From: Griffin, Tim
Sent: 25 January 2024 17:57
To: Osmond, Gary
Cc: Dyer, Tim
Subject: RM/24/96684 NETLEY FIRS, KANES HILL, SOUTHAMPTON, SO19 6AJ - landscape comments

I have been asked to provide landscape comments on this RM application.

My comments below focus on the plan prepared by Deacon Design DD650 L01 (no revision - note: drawing for some reason not titled but I assume this is the detailed landscape plan?).

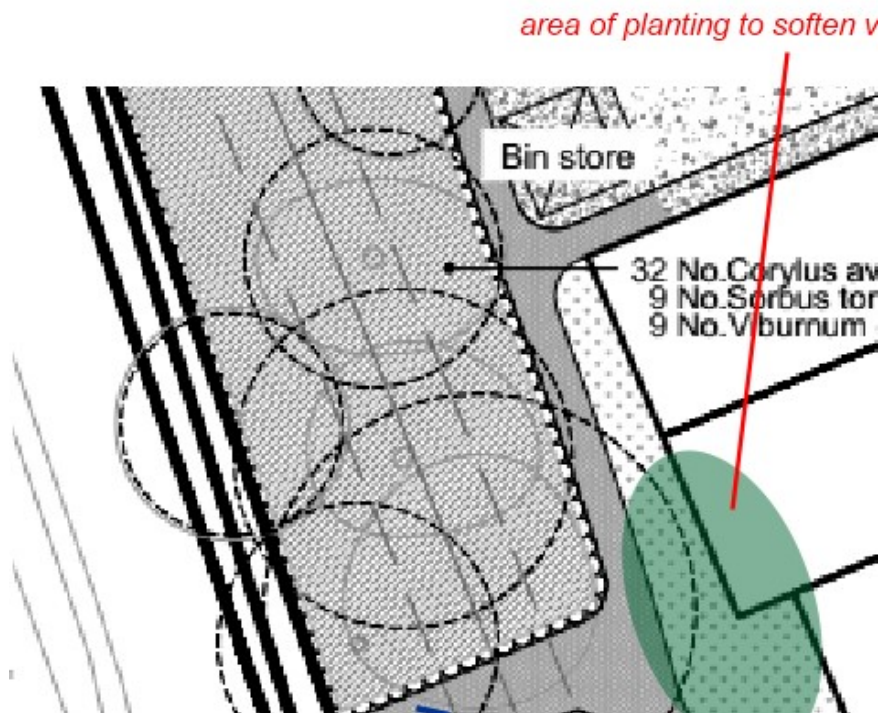
a/ The existing boundary vegetation along the frontage to Kanes Hill performs an extremely important role in screening the site. I am concerned that the notional symbol used to indicate the extent of this planting is too vague and may not reflect the on-ground situation. Looking at street view images on line there are considerable stretches of Rhododendron that perform an important year round screening role.

Please can we ask the designers to update the drawing to show the extent of existing vegetation more accurately, especially the understorey growth, so that any gaps/areas of thinner screening can be clearly shown on plan (this also applies to the boundary vegetation shown on the N & E of the site). This will then allow a more targeted specification of new screen planting in locations where it is most needed. This may require further survey work on site unless the existing topographical plan has already picked up the understorey accurately.

At present the notes on plan regarding this band of vegetation are too general and there is no way of assessing if the numbers of understorey planting allowed to fill gaps is sufficient or not. The species mix shown is curious. A % of evergreen screening plants should be included and some more obvious deciduous options such as Hawthorn. It would also be worth including a % of canopy tree species (especially Oaks) to ensure long term succession.

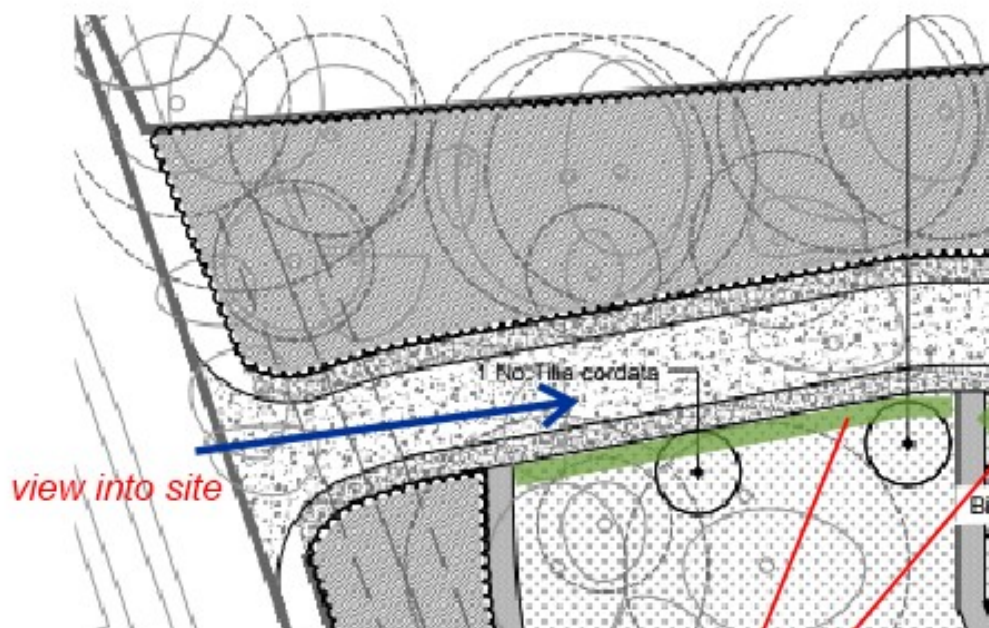
b/ The installation of a new link path onto Kanes Hill will open up a direct view into the site. An area of planting adjacent Units 6-8 will help reduce visual impact. This could be native understorey type planting or perhaps a mix of large evergreen shrubs.

c/ A further oblique view into the site will occur down the driveway. Additional native mix hedge planting as shown below will help soften this view:

d/ The location/shape of the limited area of ornamental planting (shaded red below) is odd and will be difficult to maintain. I suggest it is relocated to the location toned yellow:
